From: Waters, David [David.Waters@pgnmail.com]
Sent: Thursday, July 26, 2012 11:08 AM
To: Habib, Donald
Cc: Rose, Dana
Subject: QAPD Draft Update
Attachments: Part 11 QAPD DRAFT_RL_SO_07232012.pdf

NGGM-PM-0033

Revision 54

Title: New Nuclear Plant Development Quality Assurance Program
Description Topical Report

Figure II.1-1

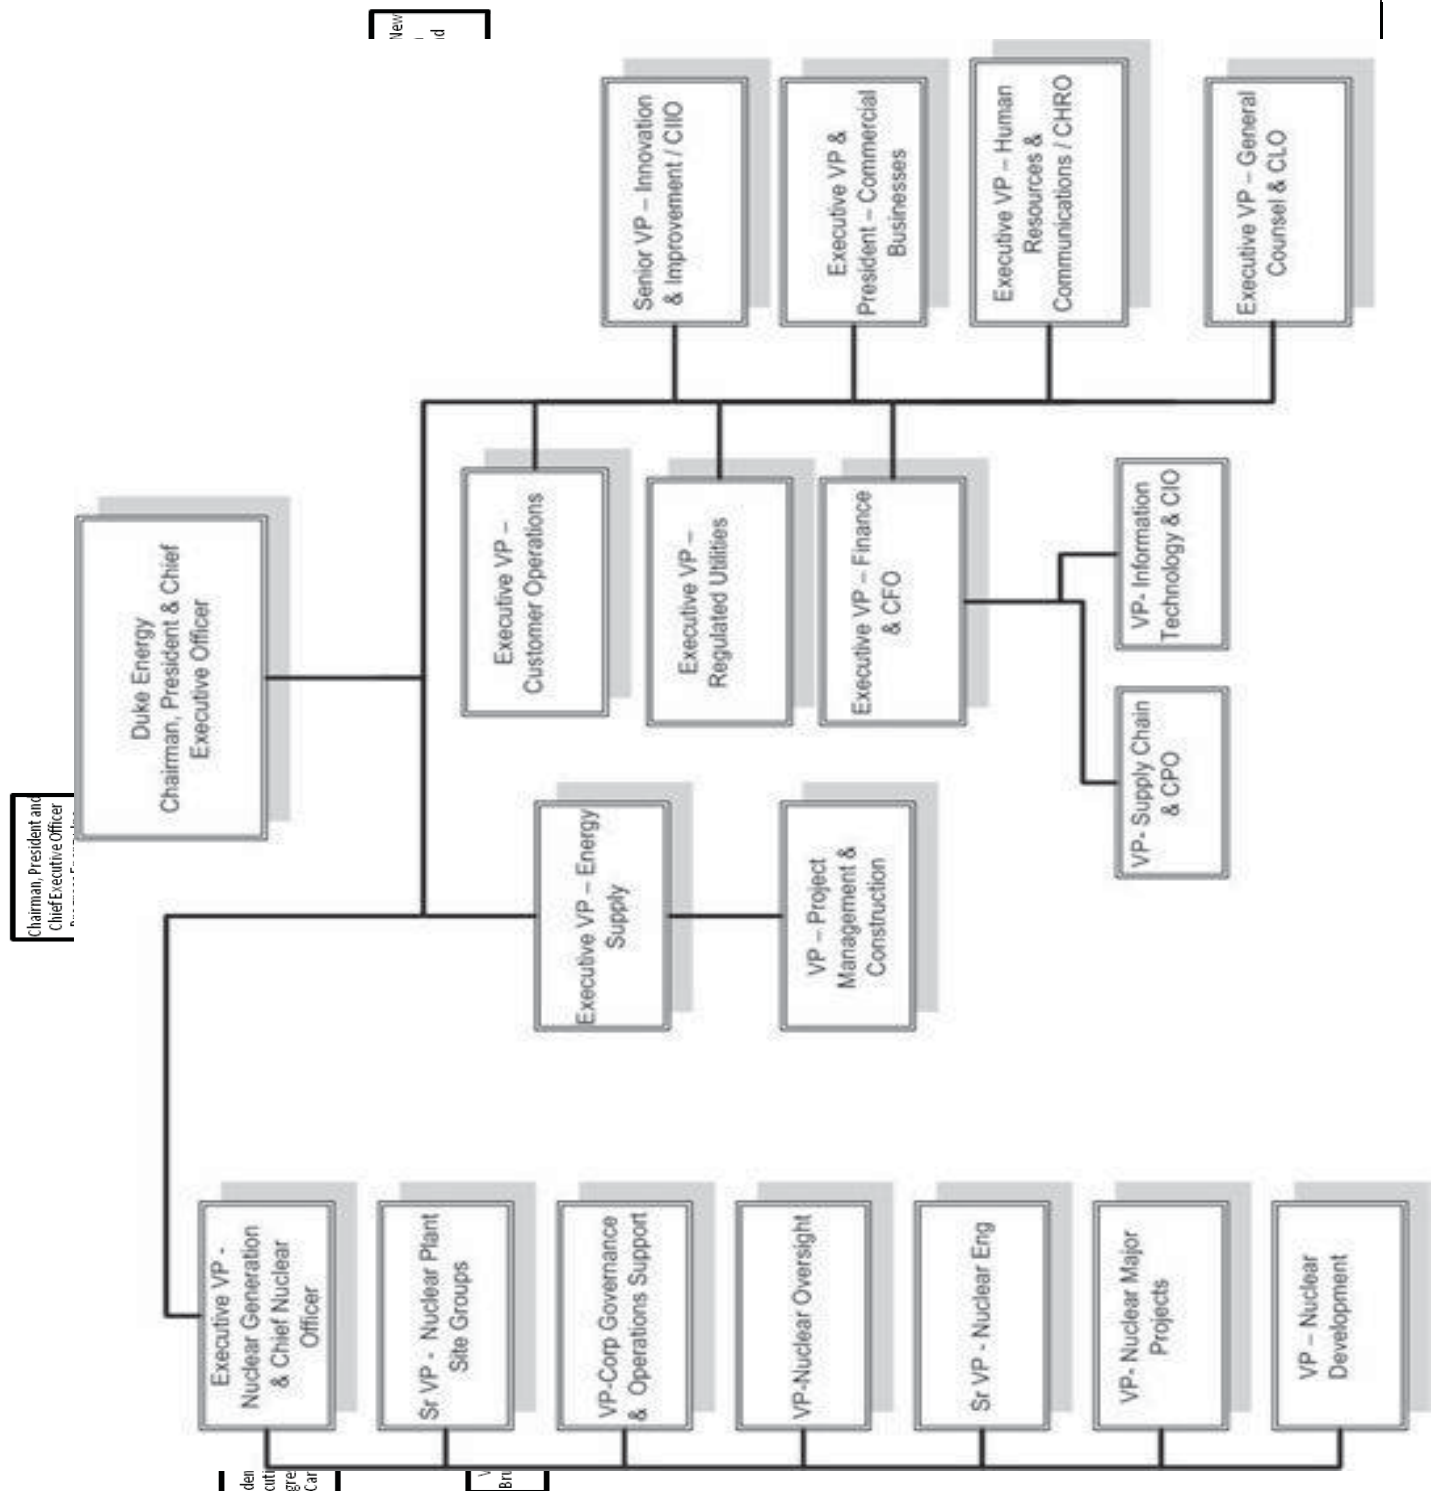
- Part II, Section 1.5 – 1.10 – Changed section numbering to reflect changes in section. No changes in section descriptions.
- Part II, Figures II.1-1, II.1-2, and II.1-3 – Revised figure to reflect new organizational structure and titles.

Figure II.1-4

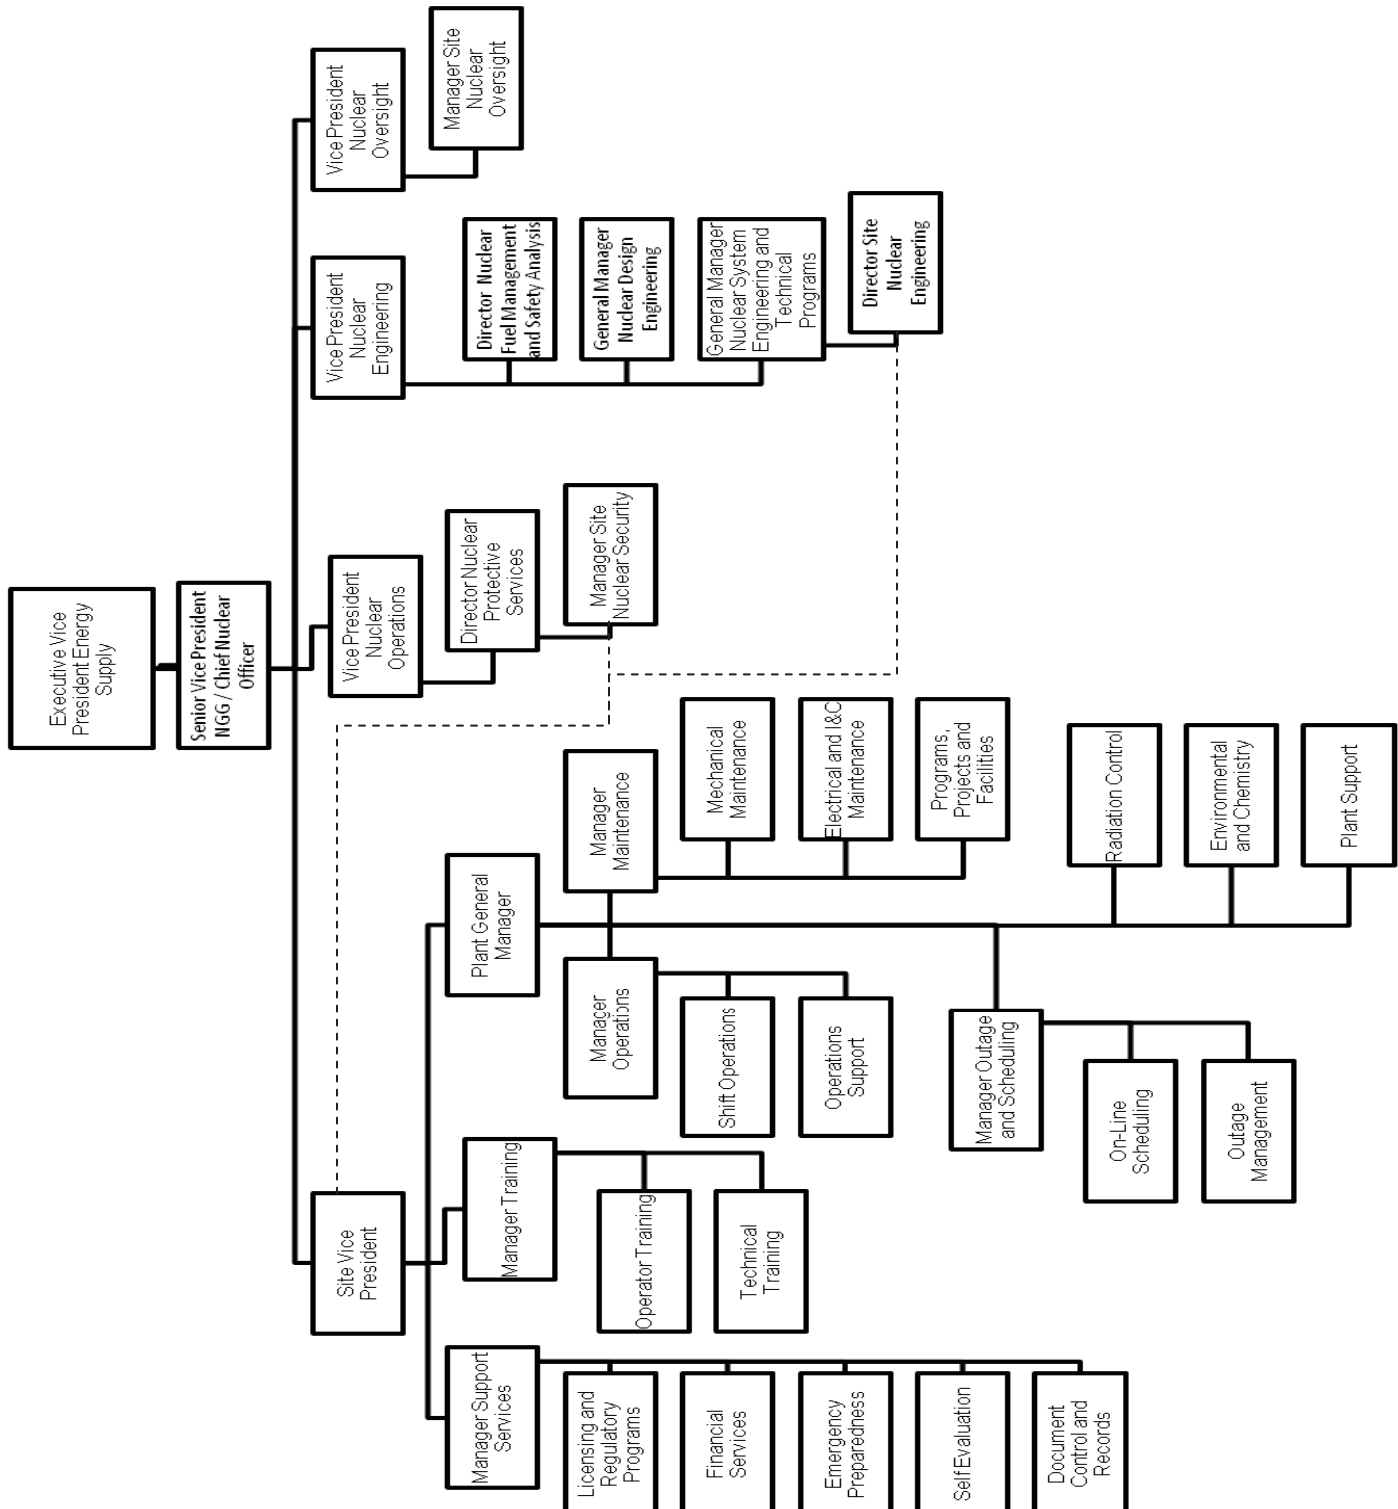
- ~~• Part II, Section 1.7, Changed CDG to CDIG.~~
- ~~• Figures II.1-1, II.1-2, II.1-3, and II.1-4 revised to reflect above noted changes in titles and reporting relationships.~~
